PERMIT

SEWAGE DISPOSAL SYSTEM

P 50026

REPAIR - PURPOSE - REQUEST FOR EVALUATION OF SEPTIC SOILS CAPACITY IN SUPPORT OF PENDING PROPOSAL FOR 1 BEDROOM ADDITION.

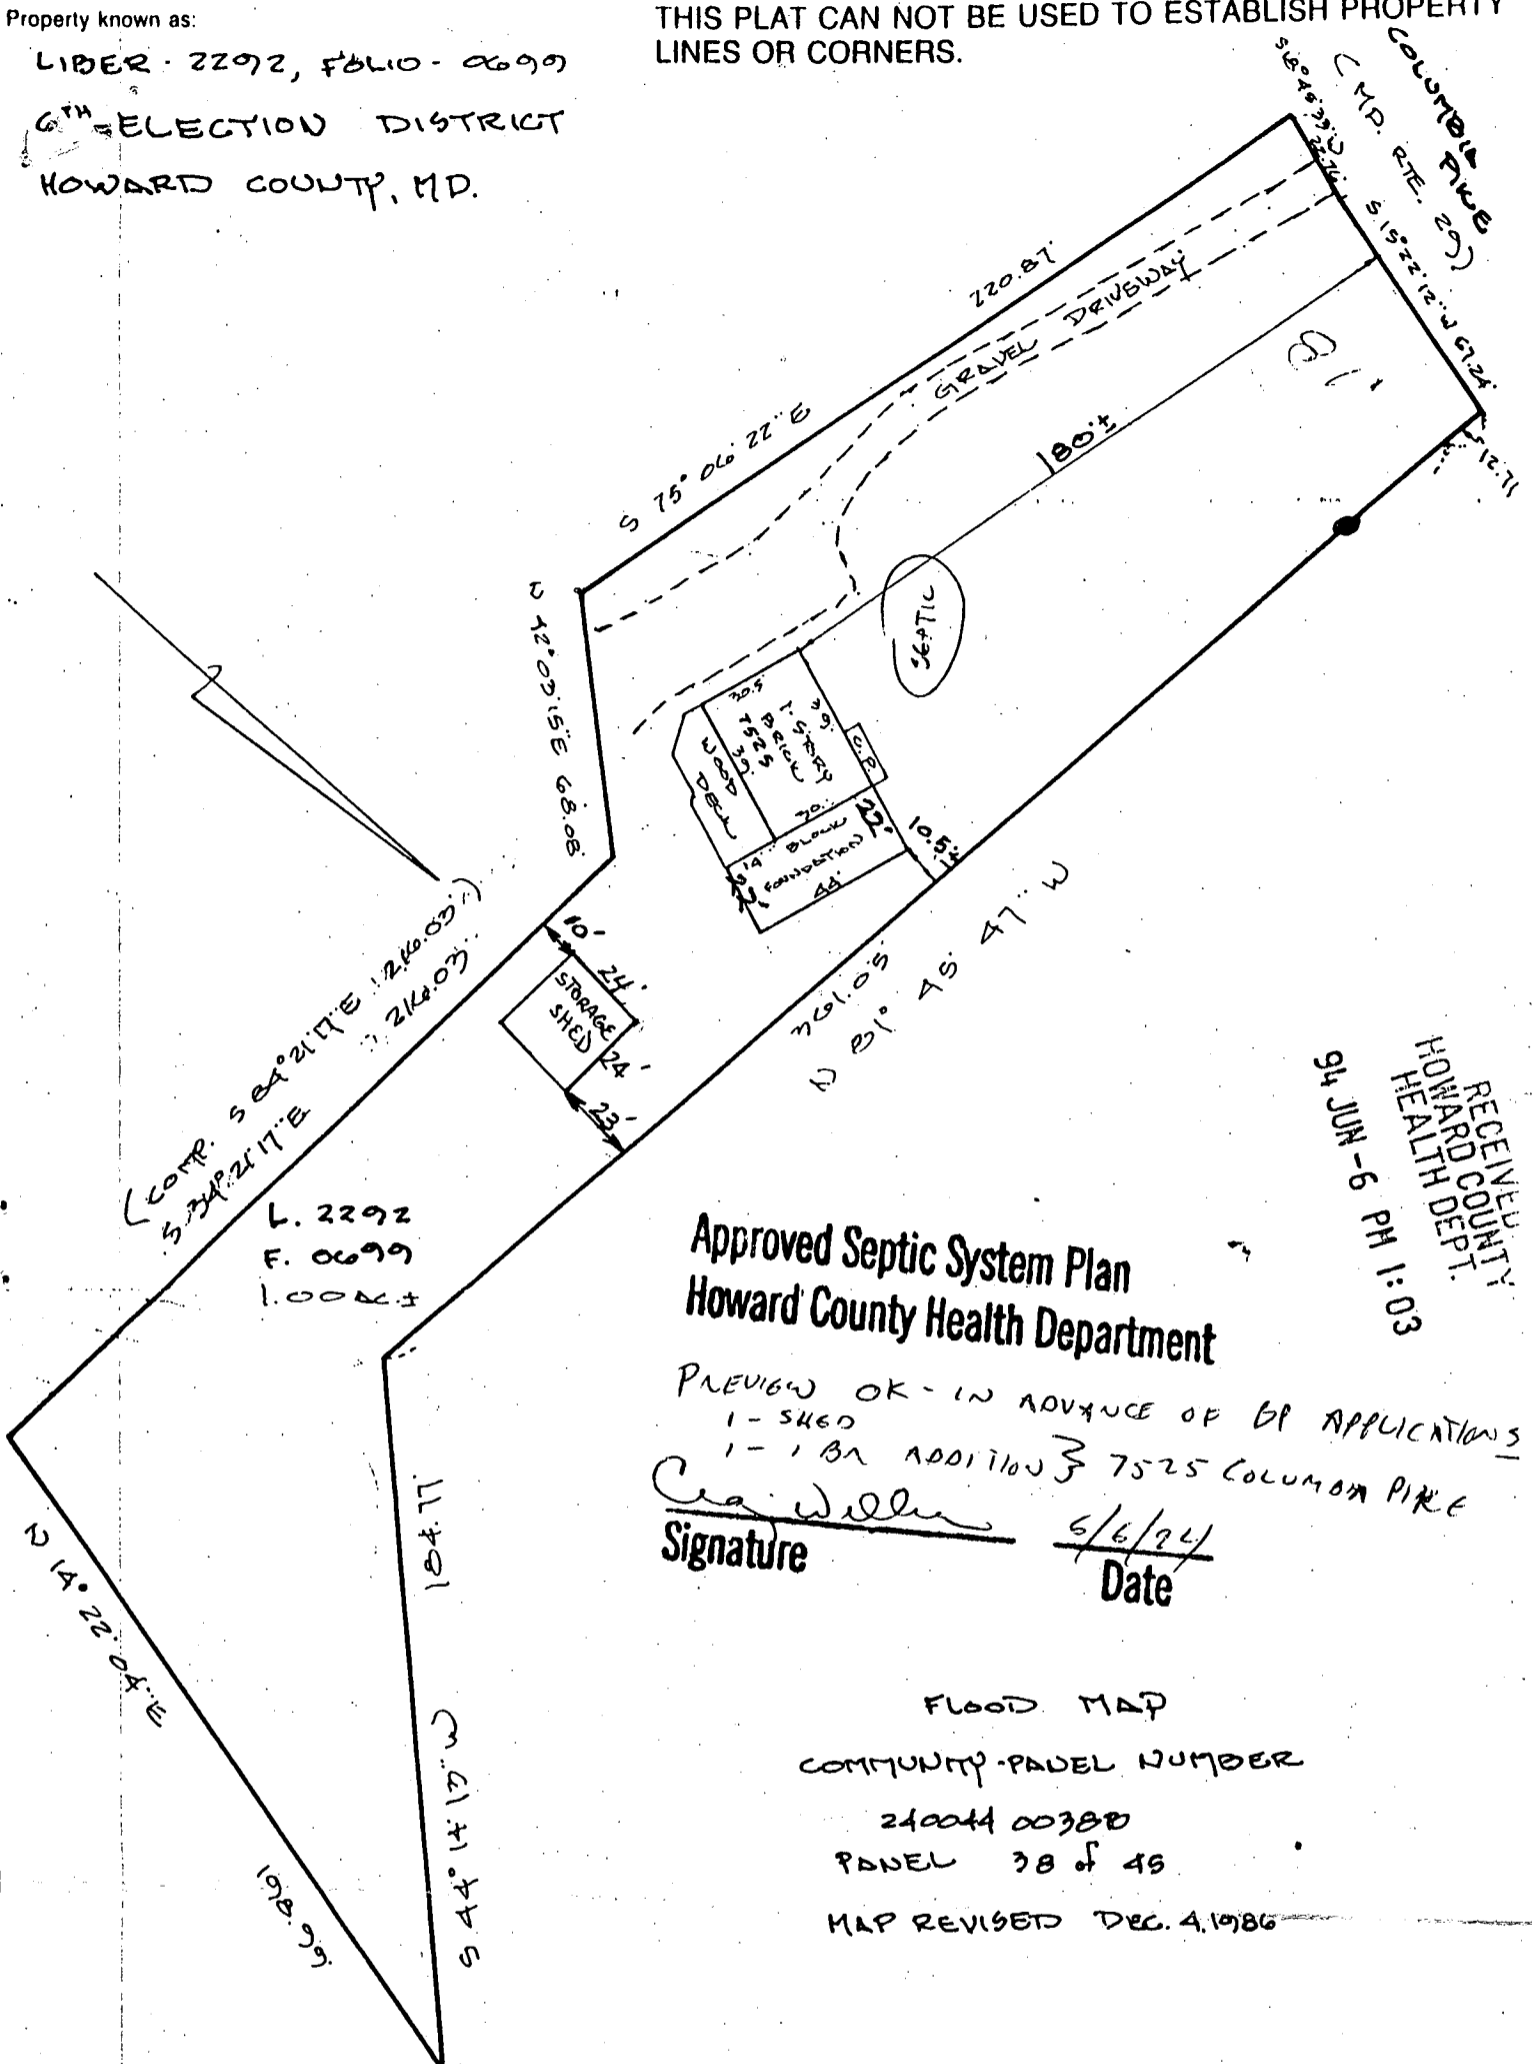
REMARKS: 5/13/94 ONE D/W REPAIR LEFT IN LOC. SHOWN; WOULD REQUIRE PUNCHING ADD'L HOLE IN EXISTING HOME-MADE S.T.; OK TO PRESENT BP FOR SIGNATURE MR

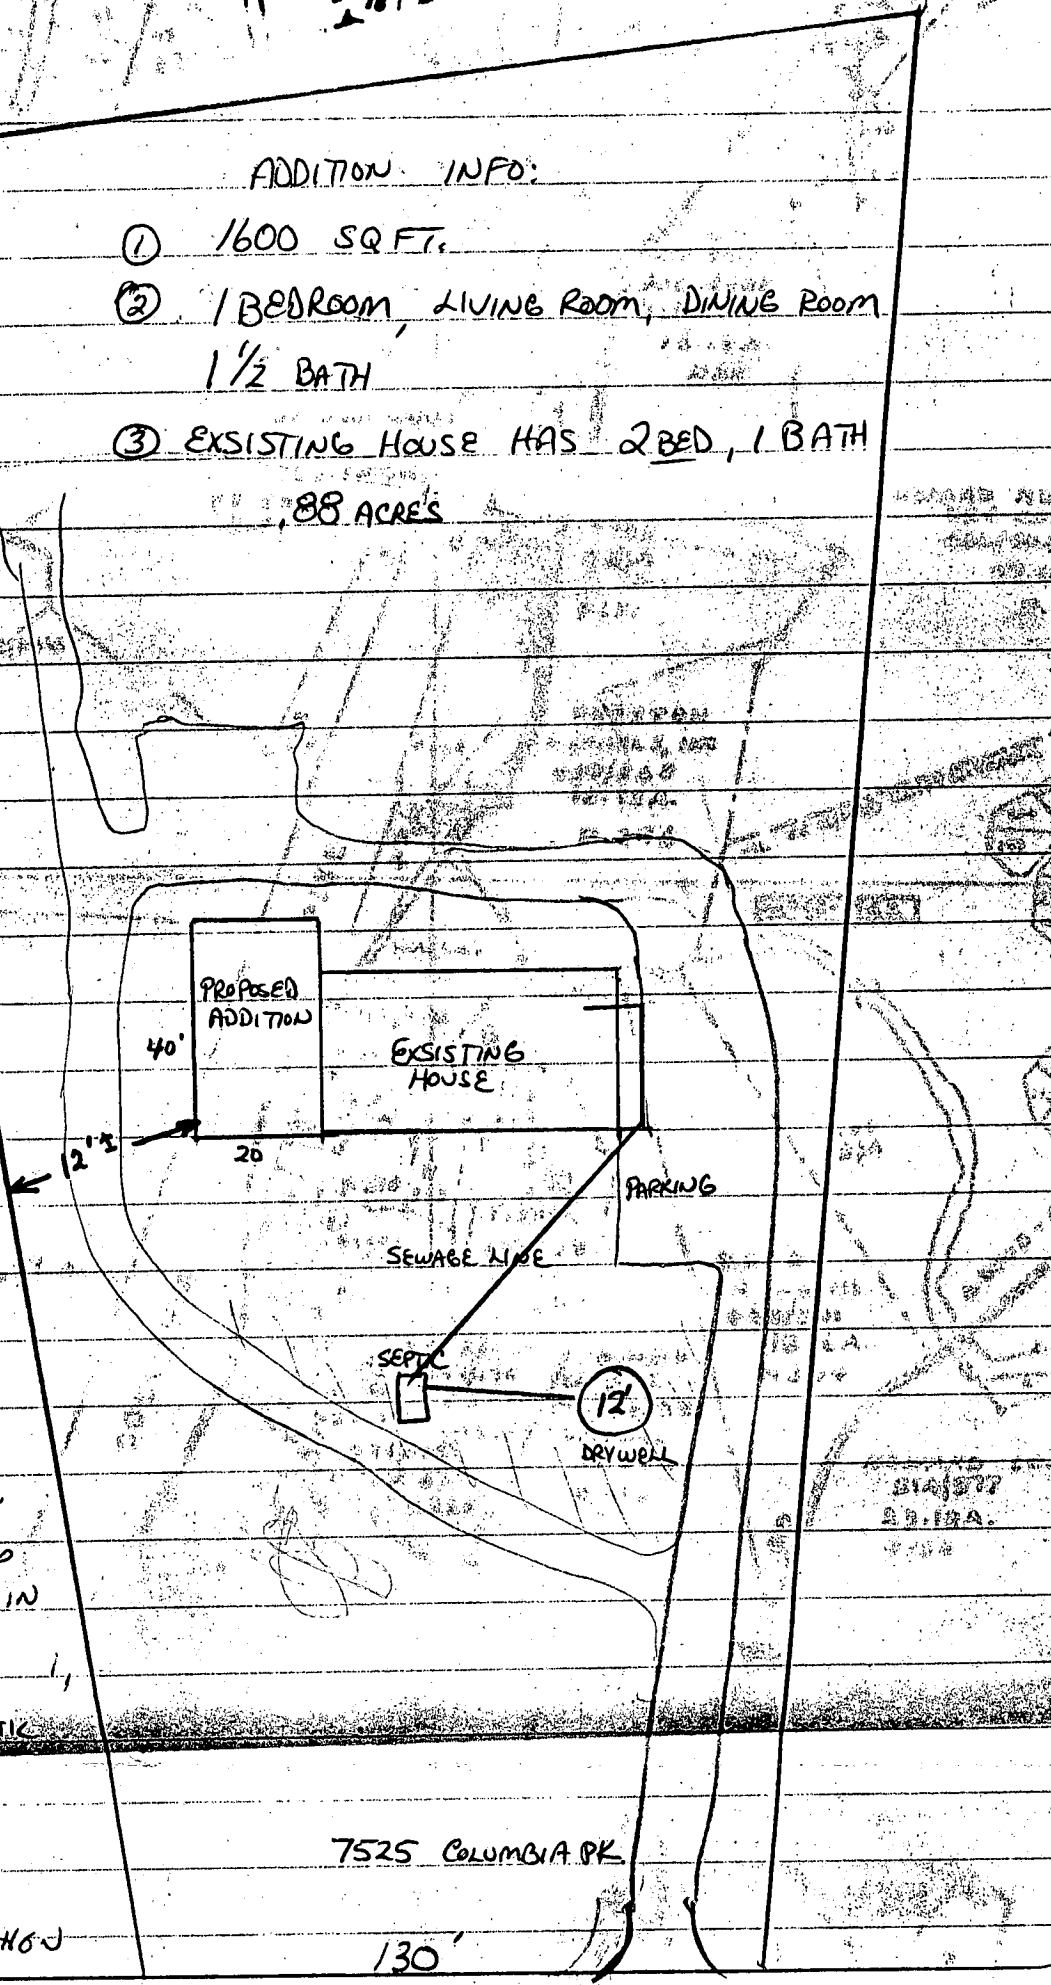
REQUEST FOR
SEPTIC REPAIR
PERMIT
FOR EVALUATION
OF SEPTIC/SOILS
CAPACITY IN
SUPPORT OF
PENDING PROPOSAL
FOR 1 BR ADDITION

NOTE TO INSPECTOR:
PROPERTY IS IN
SERVICE DISTRICT;
SEWER LINE EXPECTED
TO BE CONSTRUCTED IN
2 YRS.

IF CONDITION OF SEPTIC
IS "REASONABLE"
AND "SOME" ROOM
FOR FUTURE REPAIR
IS ESTABLISHED, THEN
NO NEED TO UPGRADE
SYSTEM AT THIS TIME.
